Rotax 912 Bed Mount Steel Bracket E1-1X June 24, 2010

Above: Cracked Rotax 912 Bed Mount Steel Bracket E1-1X

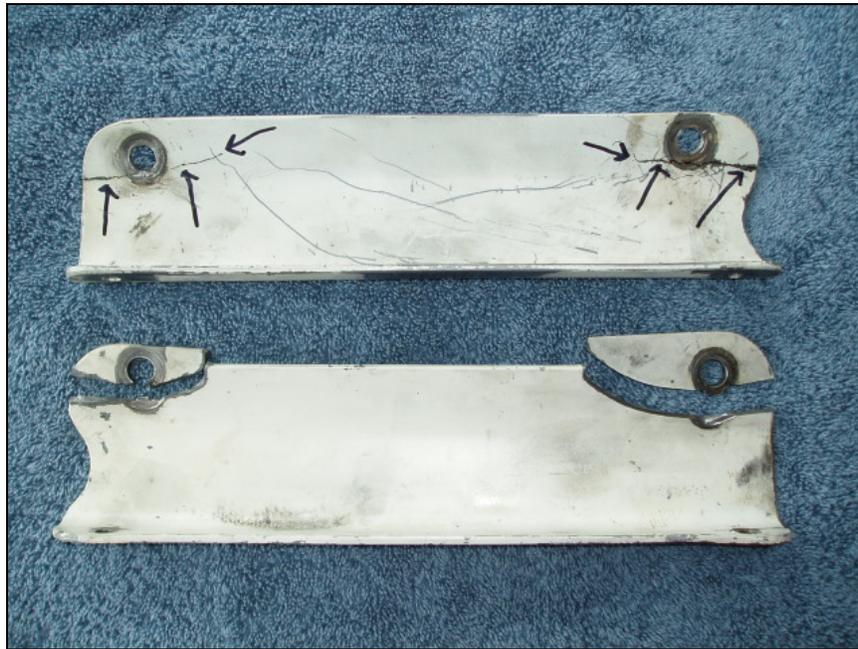
We have had reports of the earlier Rotax 912 Bed Mount Steel Brackets, P/N E1-1X, cracking around the bolt holes that mounts the Steel Brackets to the engine. This has been found on a few earlier Rotax 912 ULS engine installations and is likely caused by the higher vibrations from the 100 horsepower engine along with the rough startup and shutdown of earlier Rotax 912 ULS engines. There are several additional possible causes, including part misalignment or improper bolt torque. A change was made from mild steel to 4130, with the thickness remaining 1/8", a number of years ago to prevent the parts from cracking, and to our knowledge only the mild steel brackets have shown cracking. We need to remind all our builders, owners and operators to inspect these parts thoroughly for cracks and replace them if any cracks are found. Note that the bracket E1-1X is used with Rotax 912 series mounting on different models, including the Zodiac CH 601 and STOL CH 701 series aircraft.

On the last flight before this year's Annual, the passenger side Engine Plate Mount broke out at both bolt holes that fasten the Mount Plates to the side of the 912 Block. The other side Plate had long cracks and could also have failed (at which time the engine could have departed the airframe!). Early engine Frame Plates were constructed of Mild Steel, as were mine. The later Models and replacement Plates are 4130 Chrom-Moly Steel. A second plane in this area was inspected and also found to have cracks, starting at 194 hours.

*Because it is the Pilot/Mechanic's responsibility to watch for and repair these problems, I urge **ALL** to inspect these plates **frequently!** They are difficult to see, and must be inspected with a Flex Mirror, to be absolutely sure of their condition. I encourage anyone with Questions to contact me: Bob Jones, (907) 892-7369, and to study the (above) photo.*
